AGENDA

City of Hapeville

Design Review Committee

September 18, 2019

DRAWING INDEX A-I COVER SHEET A-2 EXISTING & PROPOSED FLOOR PLAN A-4 EXISTING & PROPOSED FRONT & REAR ELEVATION A-8 EXISTING & PROPOSED ROOF & FRAMING

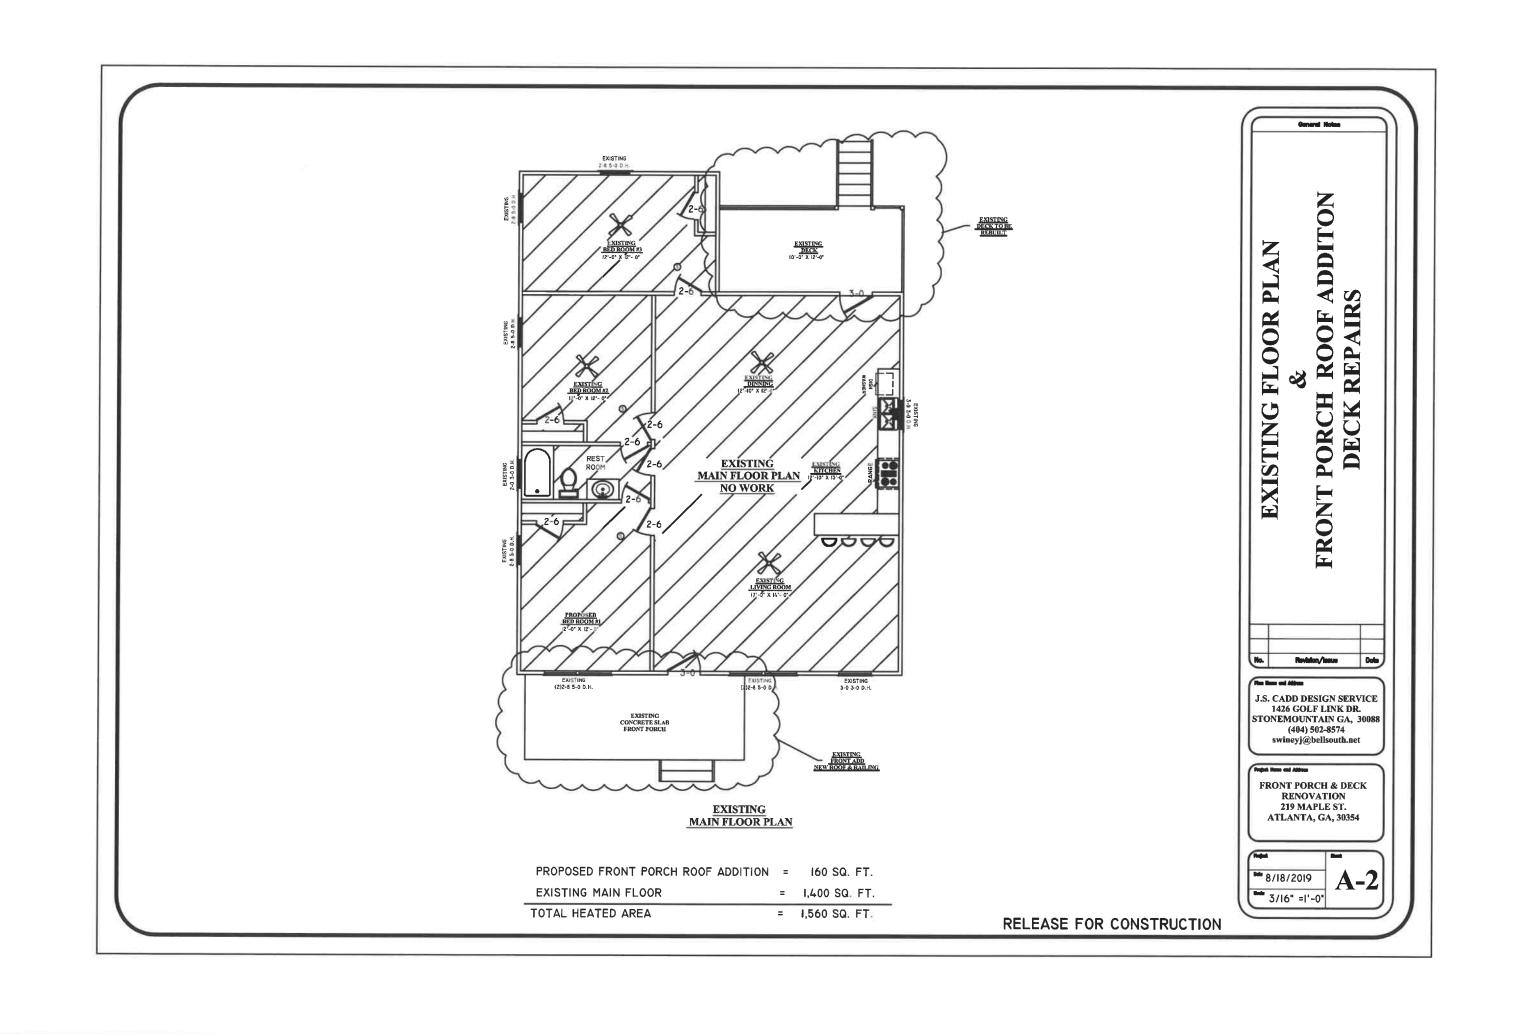
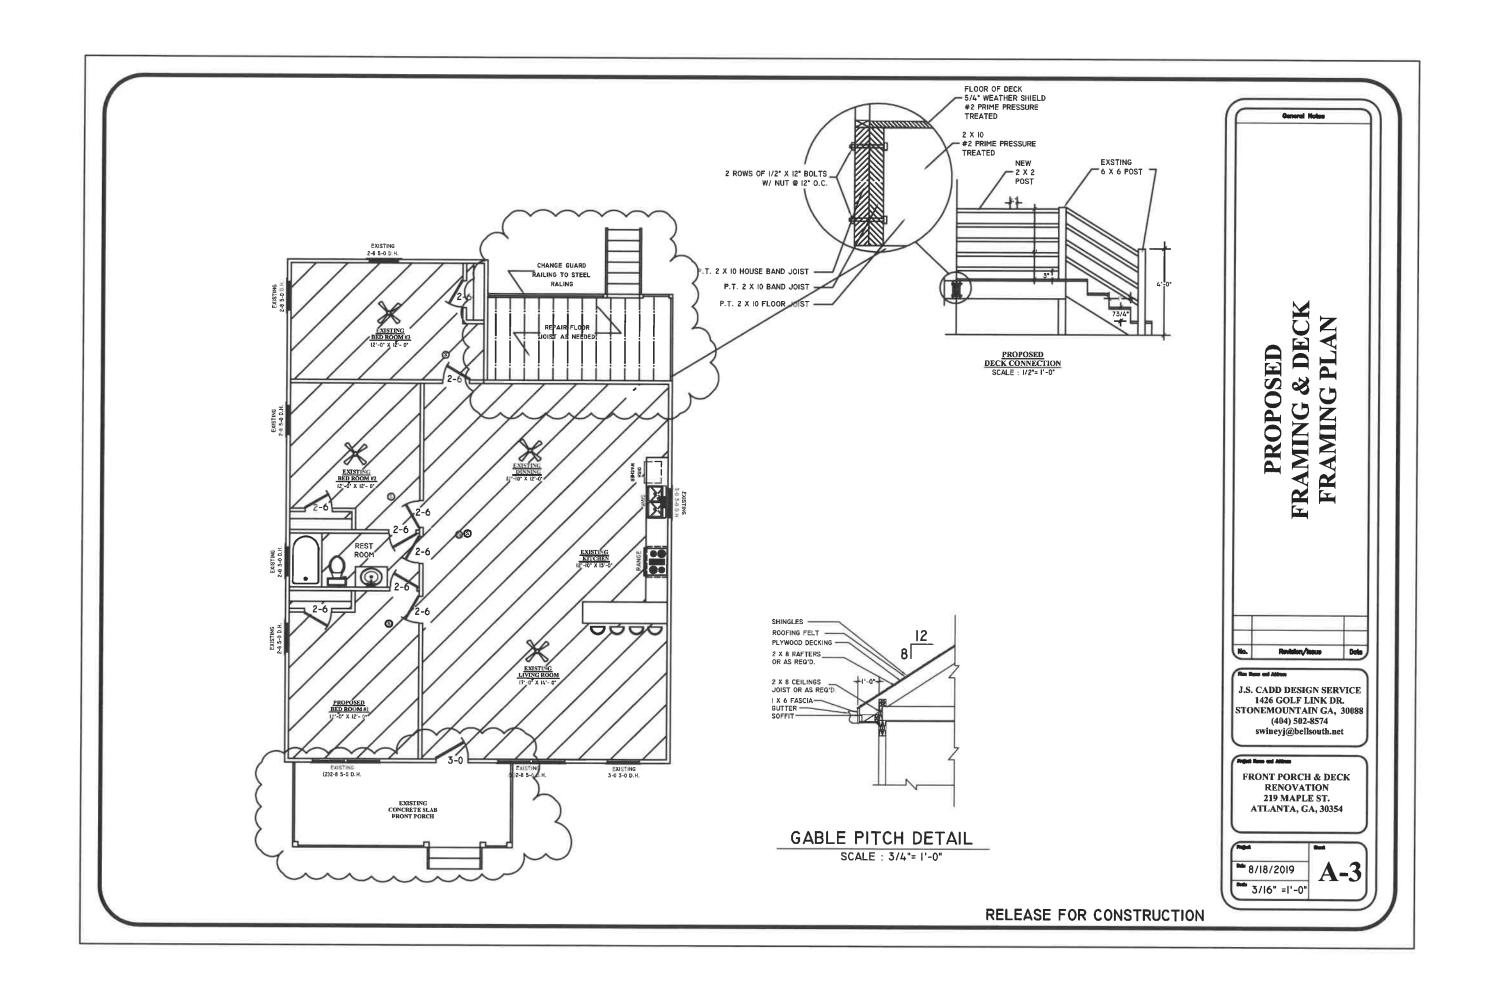
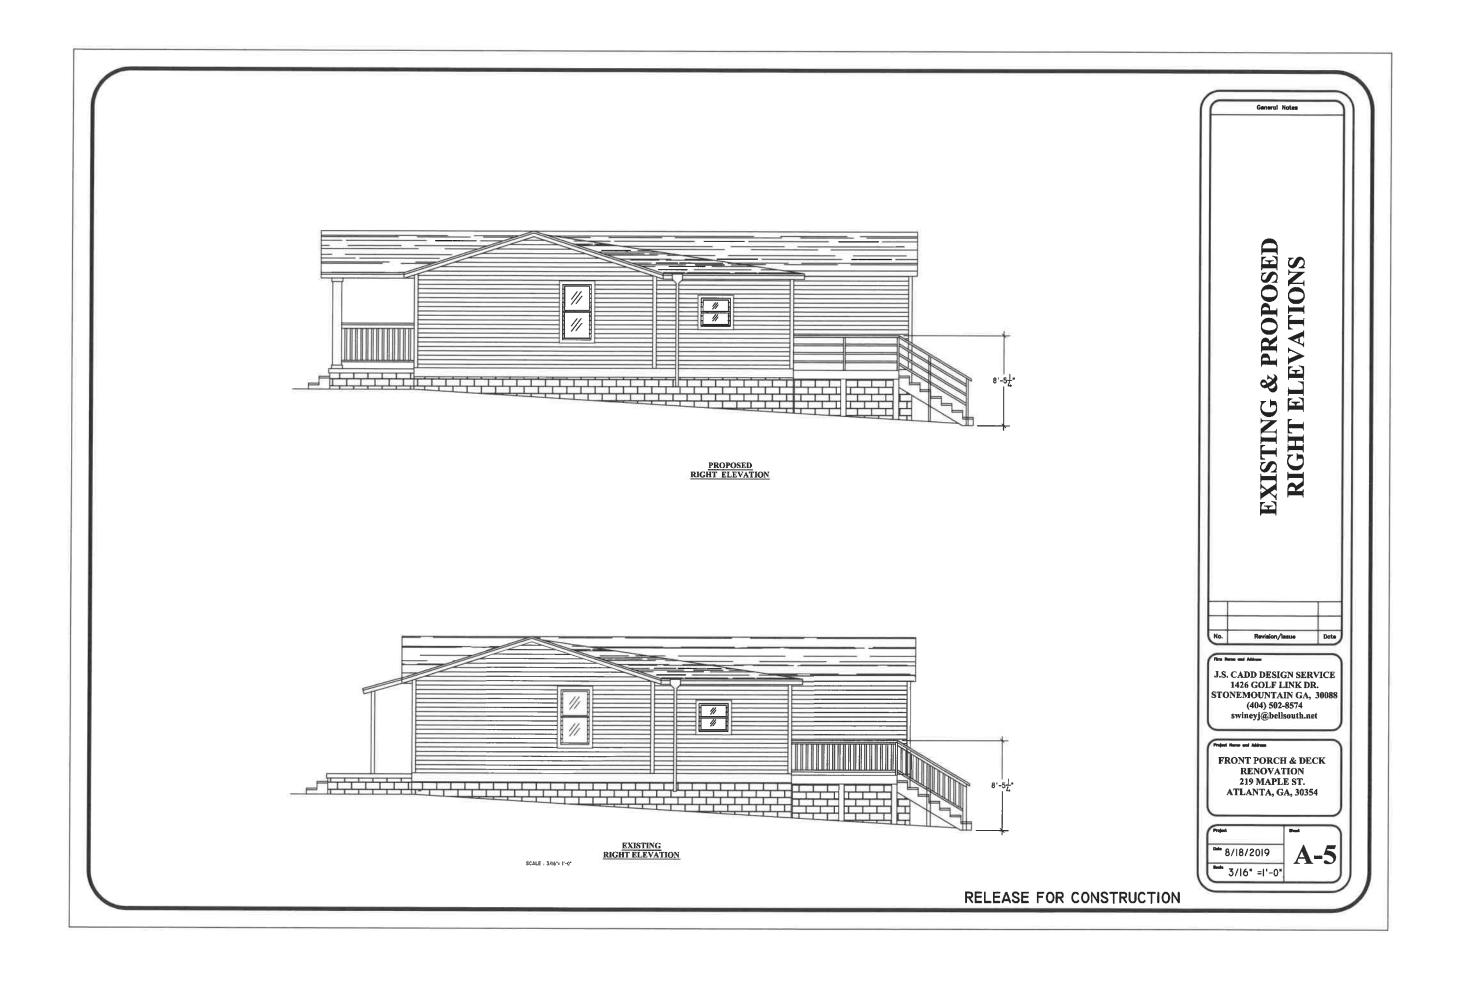
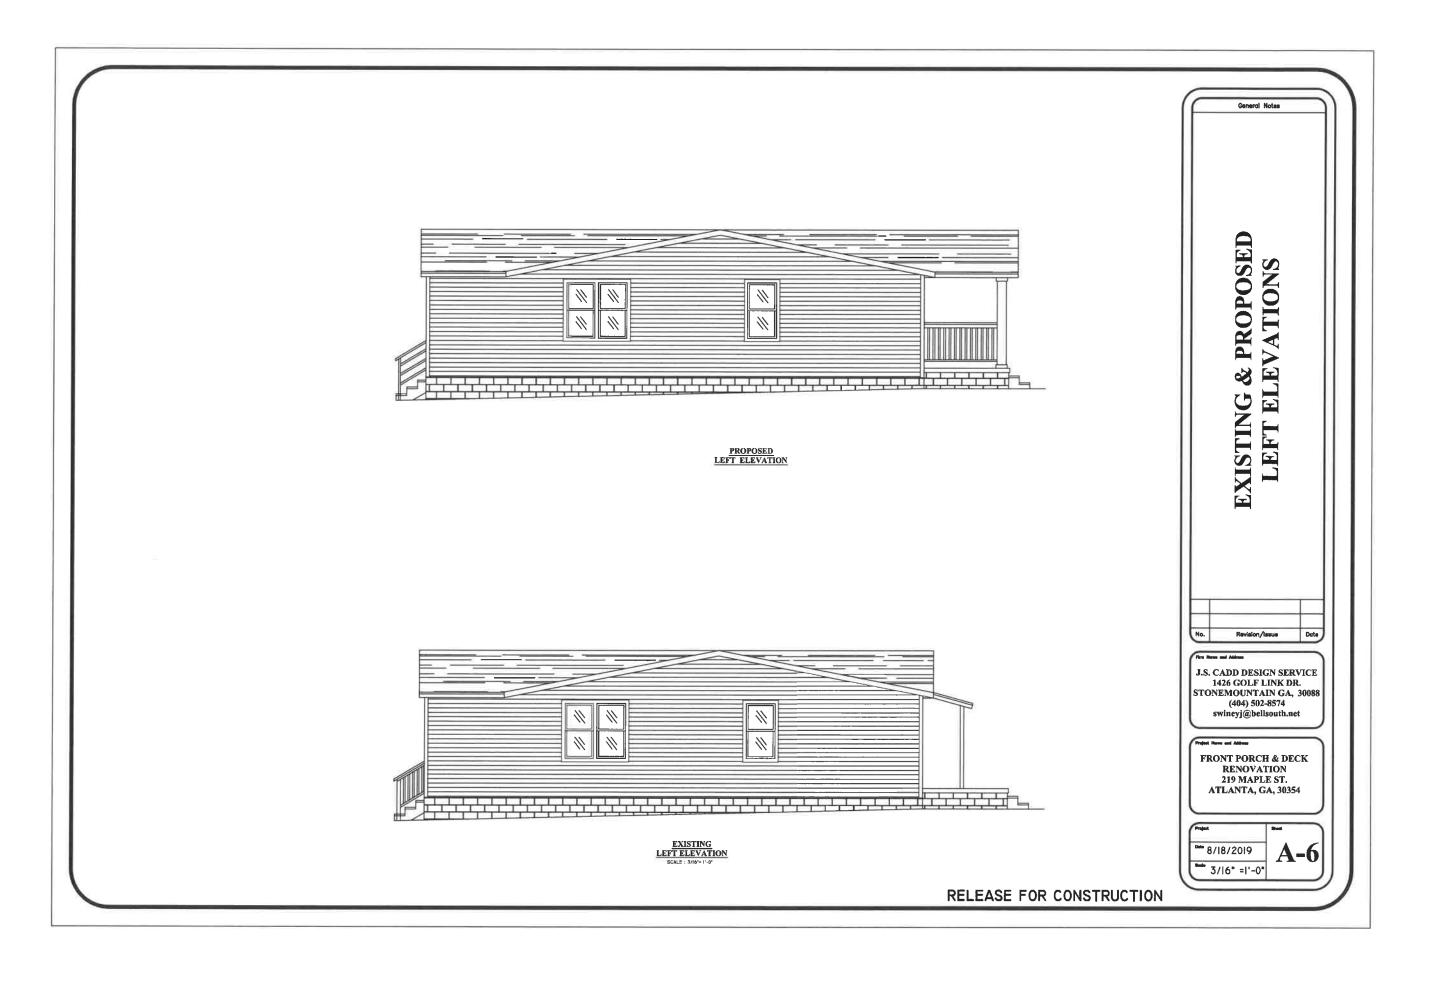
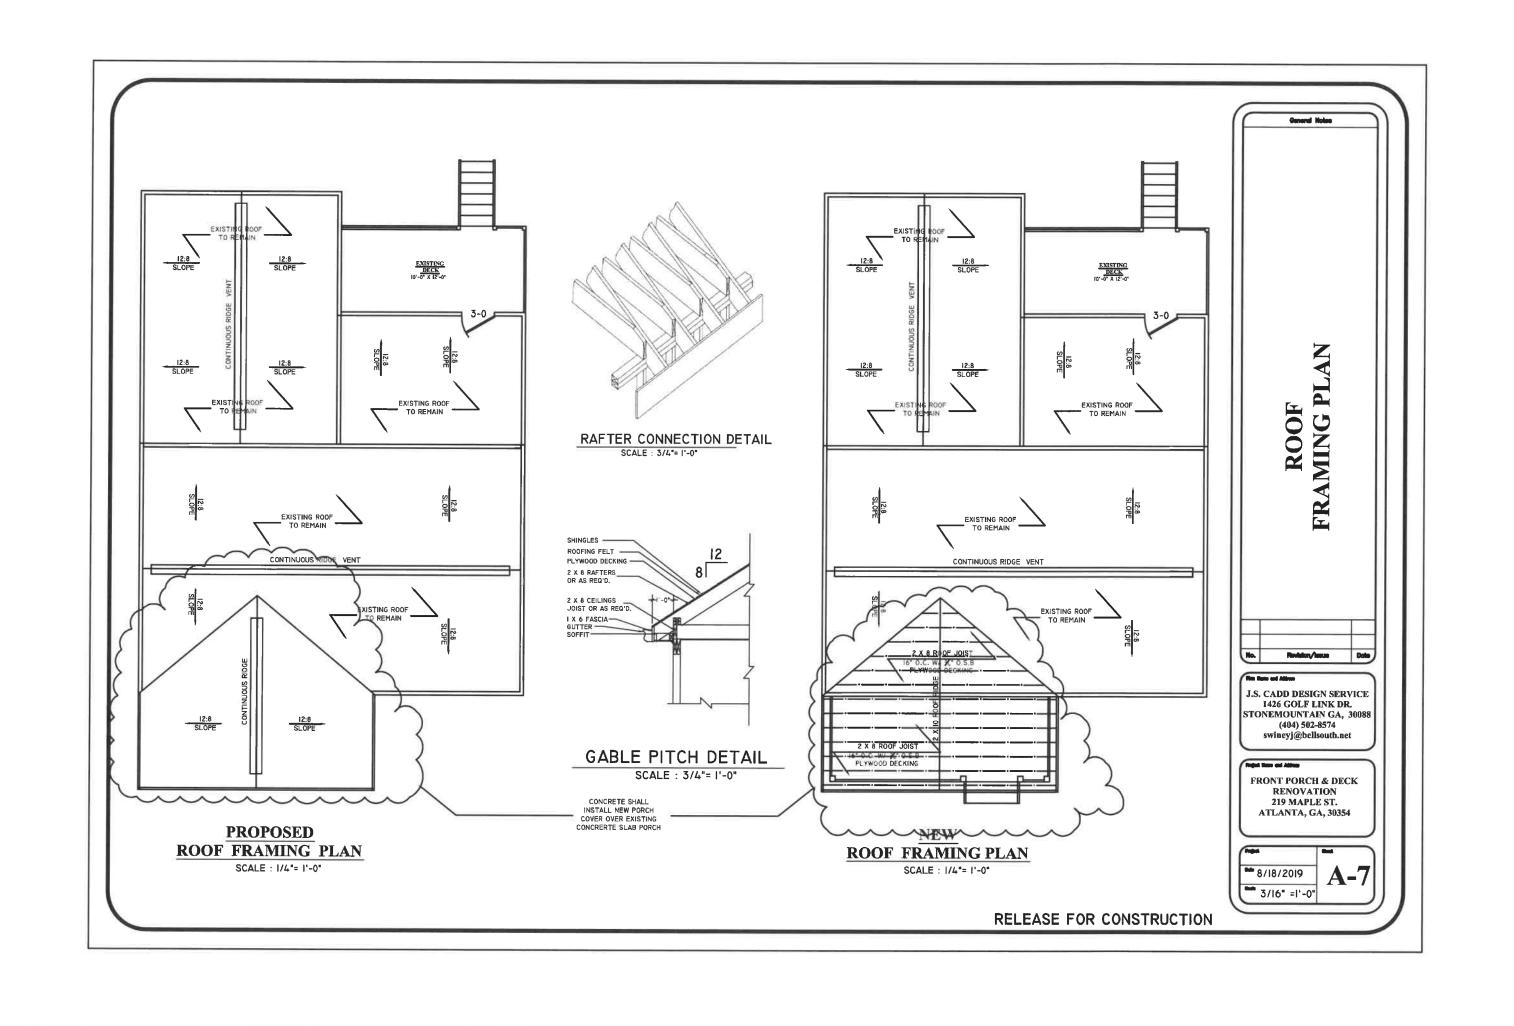
- 1. The applicant should retain the light at the front door and include it on the plans.
- 2. The applicant should ensure the shingles for the proposed porch roof match the existing shingles in style and are guaranteed for at least 30 years by manufacturer's warranty.

- 3. The applicant should show gutters and downspouts on the new roof and provide their material.
- 4. The applicant should ensure the new roof overhangs at least 12" beyond the facade.

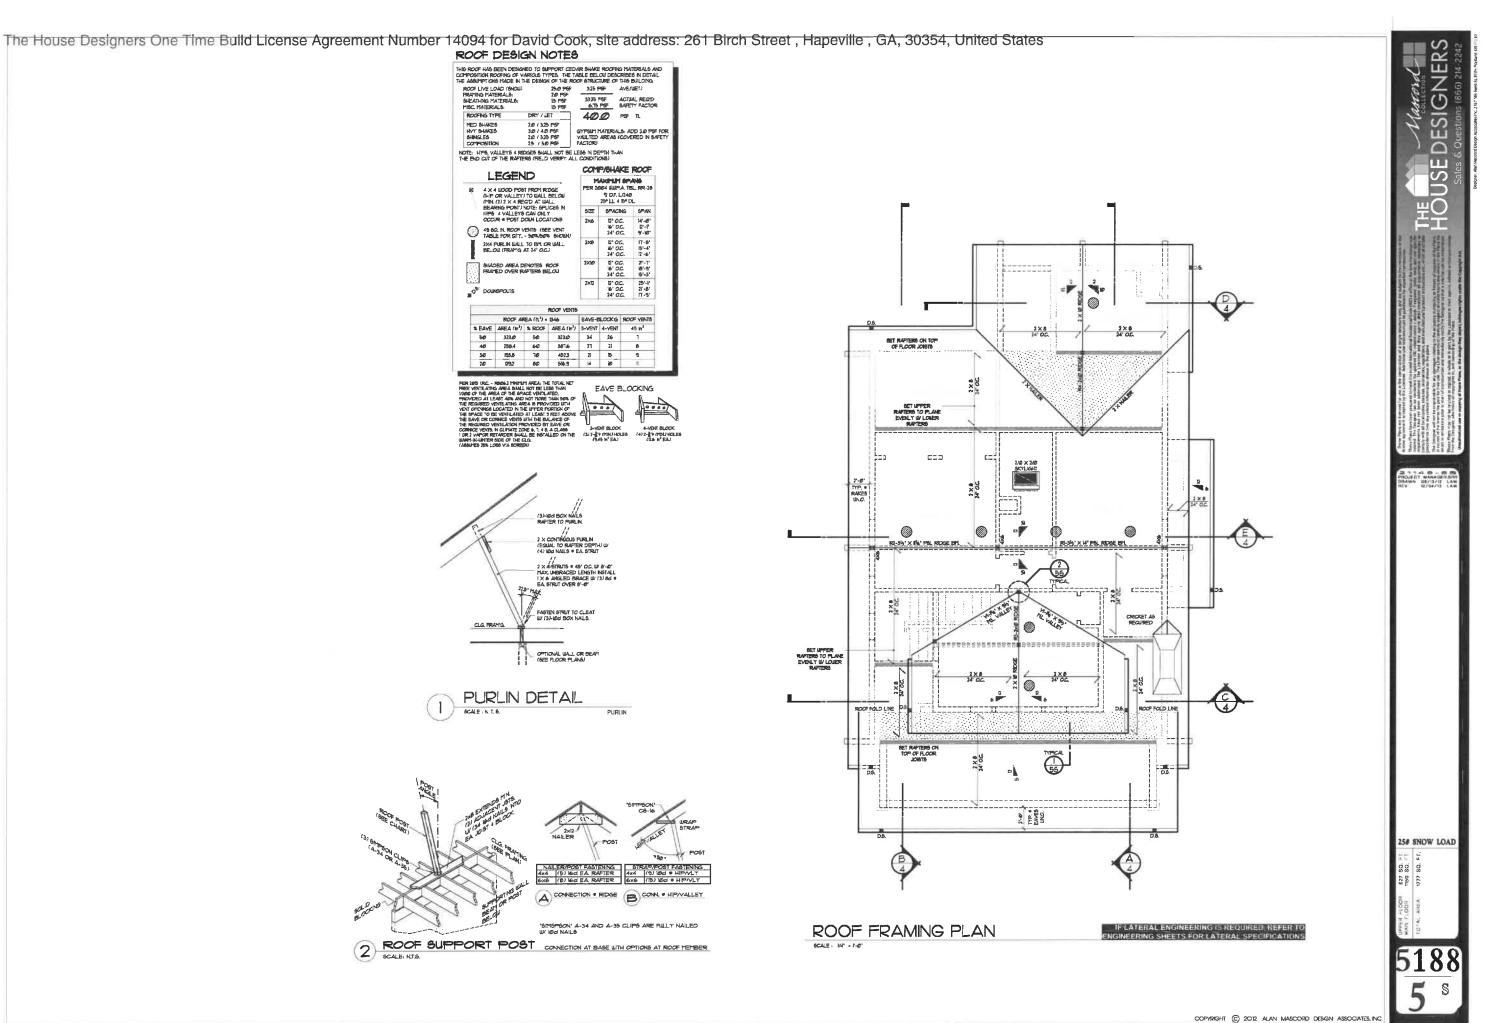
- 1. Within subarea E, the maximum height for the portion of a building between 5' and 10' from the property line is 25'. The east side setback is 9.1'. While not reflected on the submitted elevations, an updated site plan provides the height as approximately 30' above grade with no reduction approaching the side setbacks, which is not compliant.

- 2. A fence between 6" and 48" in height is encouraged at the back of the required sidewalk.
- 3. The applicant should show mechanical utility features on the plans and indicate any screening.

- 4. A light at the front door should be included and shown on the plans.
- 5. The plans indicate the roofing material will consist of cedar shake and "composition" shingles. **The applicant** should ensure all roof shingles are slate, cedar, or asphalt.

- 6. The applicant should provide the manufacturer's warranty, ensuring the roof is warrantied for at least 30 years.
- 7. The applicant should specify the distance the roof overhangs the facades of the house, ensuring it is at least 12".

- 8. The applicant should describe the material of the gutters and downspouts and show them on elevations.
- 9. The applicant should clarify if the foundation will extend above grade and, if so, should design it to contrast with the facade materials.

- 11. Porches must be between 2' and 4' above grade. The applicant should provide the height of the porch above grade.

- 13. Porch columns may be spaced no more than 8' apart on center. The porch columns are approximately 26' apart, which is not compliant.
- 14. Building numbers at least 6" in height on the porch or adjacent to the front door should be included and shown on the plans.

- 15. The applicant should ensure no GBGs will be utilized.
- **16.** Windows must comply with all requirements of Sec. 81-1-7(g) *Door and window standards*. **The elevations** should be revised to demonstrate compliance and the plans should provide the following information:

- 17. The applicant should provide the height of the finished first floor above grade, ensuring it is between 2' and 4'.
- 18. The applicant should provide the height of the first story windowsills above the finished first floor, ensuring they are between 2.5' and 3.5' high.
